**STAFF REPORT**  
( Final Plat)

**CASE NUMBER:** S/D 95-48 QUIK TRIP 6TH ADDITION

**LOCATION:** North of 21st Street North and east of Arkansas

**VICINITY MAP:**

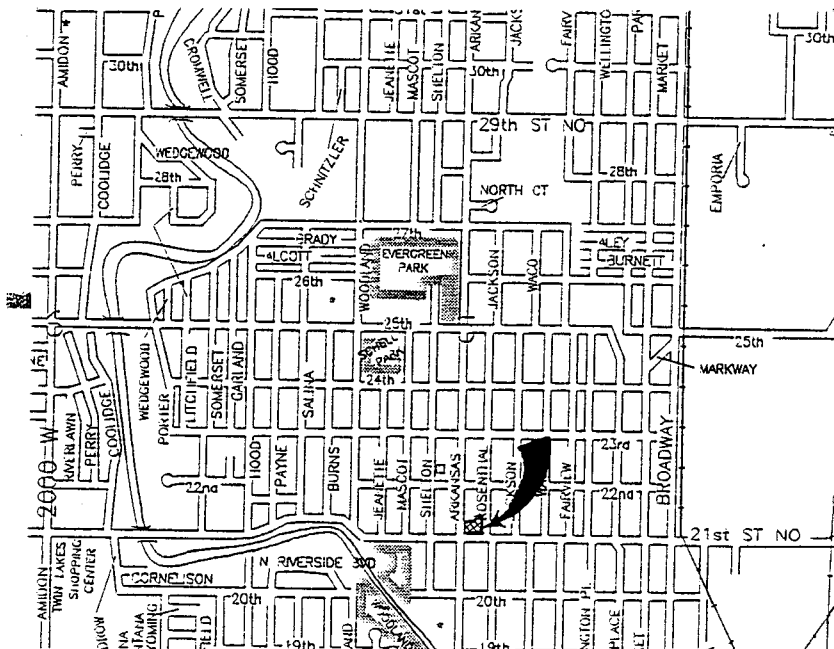
- I. In regard to access controls, the final plat tracing shall note both on the face of the plat and in the plattor's's text that complete access control to Rosenthal is being established for the area north of the one (1) planned opening. To prevent the alley from being used as a means of Commercial Access, complete access control shall also be platted from this site to the alley.

The plattor's text shall also be revised to agree with the areas of complete access control shown on the face of the plat to 21st and Arkansas streets. That is, the text shall also indicate a "100" foot dimension to 21st and a "60" foot dimension to Arkansas.
